# United States Patent and Trademark Office

APPLICATION NO.	FILING DATE	FIRST NAMED INVENTOR	ATTORNEY DOCKET NO.	CONFIRMATION NO.
10/511,325	10/15/2004	Tsutomu Yoshitake	Q84259 9221	
23373 SUGHRUE M	7590 10/04/2007 ION. PLLC		EXAMINER	
2100 PENNSYLVANIA AVENUE, N.W.			LEWIS, BEN	
SUITE 800 WASHINGTO	N. DC 20037		ART UNIT PAPER NUMBER 1795	
	- <b>,</b>			
		•	MAIL DATE	DELIVERY MODE
			10/04/2007	PAPER

#### **DETAILED ACTION**

2. Claims 33-40 and 42-45 are rejected under 35 U.S.C. 103(a) as being unpatentable over Uchida et al. (U.S. Patent No. 6,057,051) in view of Johnson (U.S. Patent No. 6,808,833 B2).

FIG.1

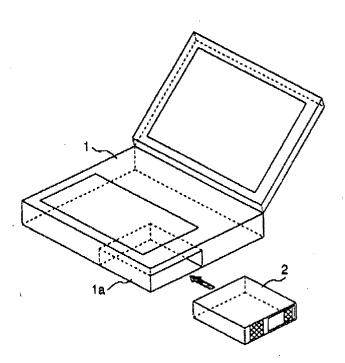
With respect to claims 38-39, Uchinda et al. the fuel cell device **2** "power generating section" is detachably received in a cell device-receiving portion la of an equipment **1** "heat producing section", such as a personal computer and the like, for which a cell power source is required (Col 5 lines 54-67) (See Fig. 1).
